ADDENDUM NUMBER **THREE** TO BIDDING DOCUMENTS

NEW FIRE STATION – PUTNAM VALLEY FIRE STATION #1 OSCAWANA LAKE ROAD PUTNAM VALLEY, NY 10579

Date: March 12 2021

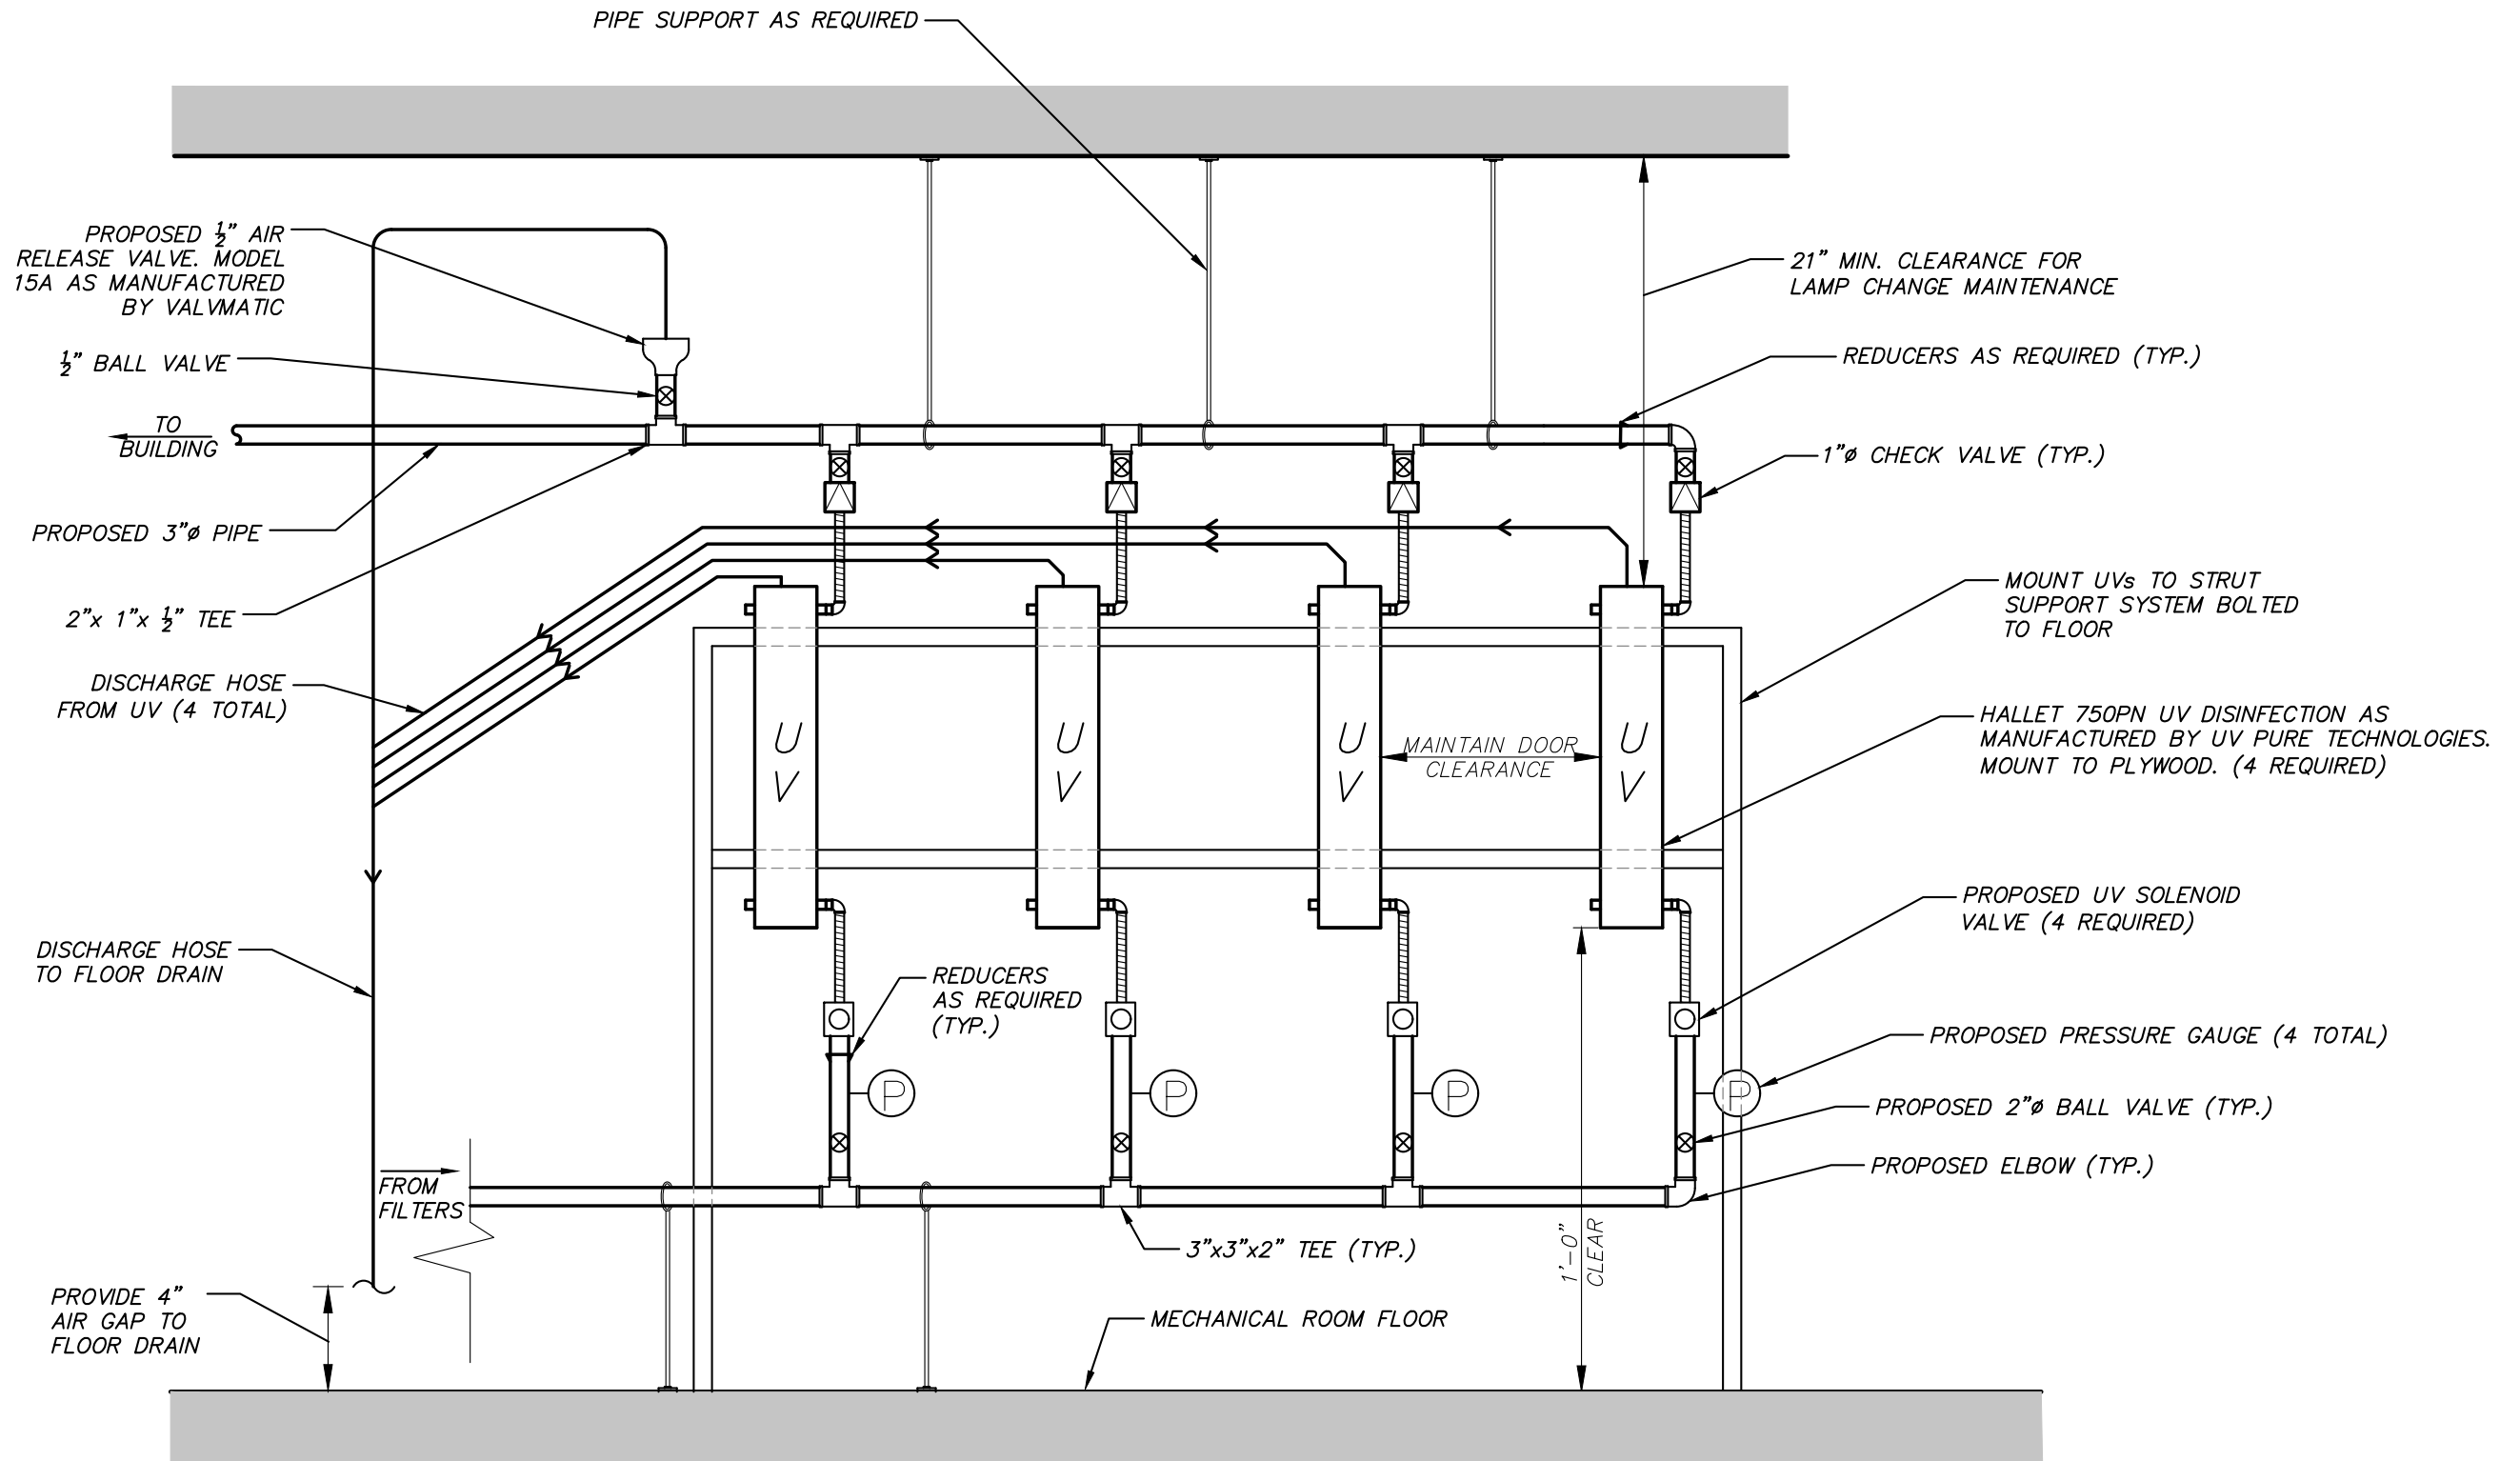
- Q: Are footing drains proposed? Please identify where they are shown, material type, bedding and where they will daylight.
- A: Footing drains shall be provided as shown on Drawing S-104, A100, A410, A411, and A413. Footing drains shall be 8” diameter HDPE N-12 pipe and in areas not specified on structural drawings the installation shall be per the Drainage Line Trench Detail on Drawing D-2. The Building Footing Drain and Retaining Wall Footing Drain shall combine, and the combined Footing Drain discharge locations have been revised as shown on the attached sketch SK-1, dated 03/11/2021.

- Q: Please clarify where the retaining wall drains daylight, material and bedding.
- A: As mentioned in the above response, the combined Footing Drain discharge locations have been revised as shown on the attached sketch SK-1, dated 03/11/2021. The pipe shall be 8” diameter HDPE N-12 pipe and the installation shall be per the Drainage Line Trench Detail on Drawing D-2.

- A. SP-2.1:
 - 1. **REVISE** footing drain as indicated on the attached sketch SK-1, dated 03/11/2021.
- B. SK-2:
 - 1. **ADD** attached sketch SK-2, dated 03/11/2021.
- C. SK-3:
 - 1. **ADD** attached sketch SK-3, dated 03/11/2021.
